Conditional Use Permit:
Day Care
Seaside Chapel – 105 Dow Road

September 10th, 2020
Miles Murphy – Senior Planner

Design

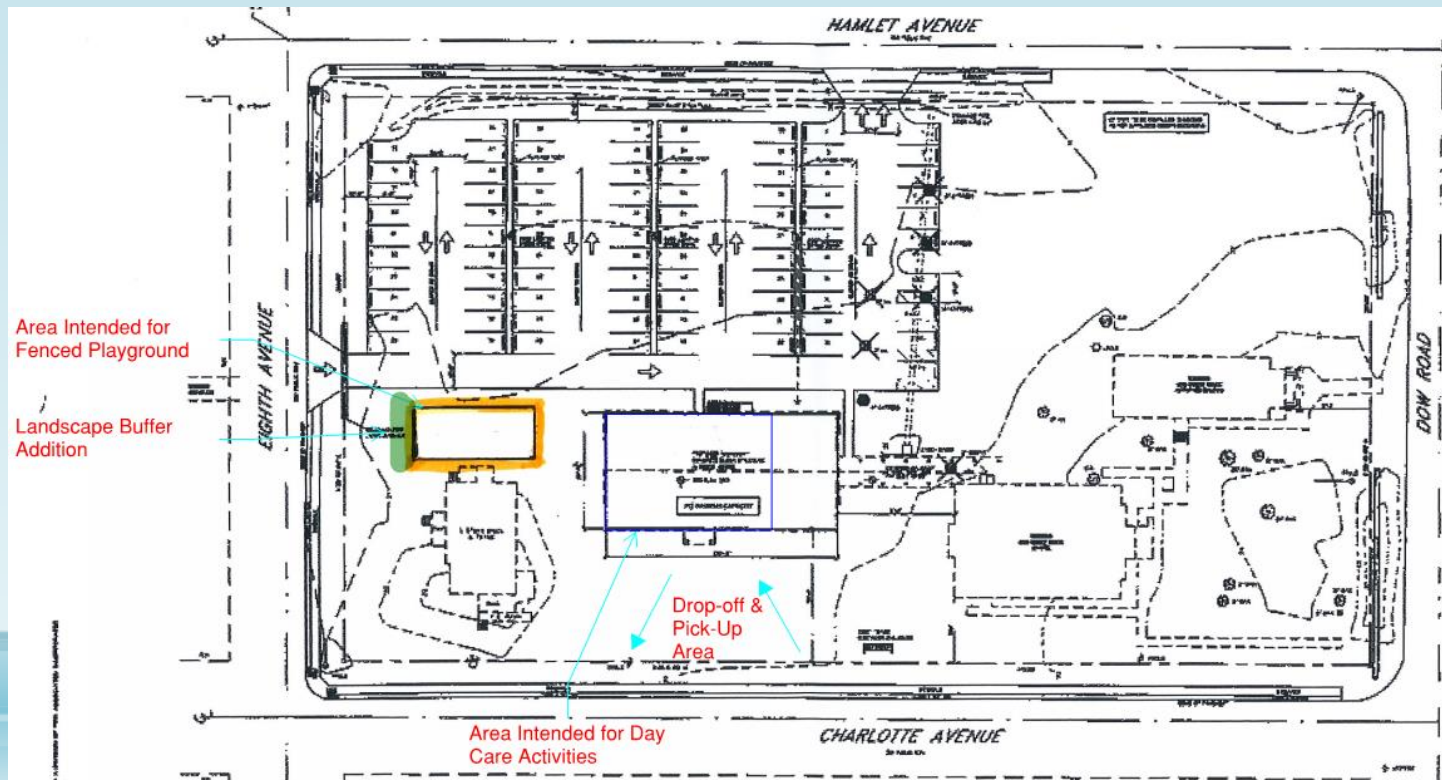
- Staff is requiring additional buffering to be placed on the edge of the proposed playground area
 - Original CUP in 2005 controlled the larger property's landscaping, parking, and buffering
- SW did not require the parking lot to be finished beyond its current condition
- Childcare/Day Care ratios and safety requirements are reviewed by agencies outside of the Town
- No additional improvements or requirements from TRC

- A landscape buffer is being required on the 8th street side of the proposed fenced playground area
- (6) *Signs*, if any, and proposed exterior lighting with reference to glare, traffic safety, economic effect, and compatibility and harmony with properties in the district;
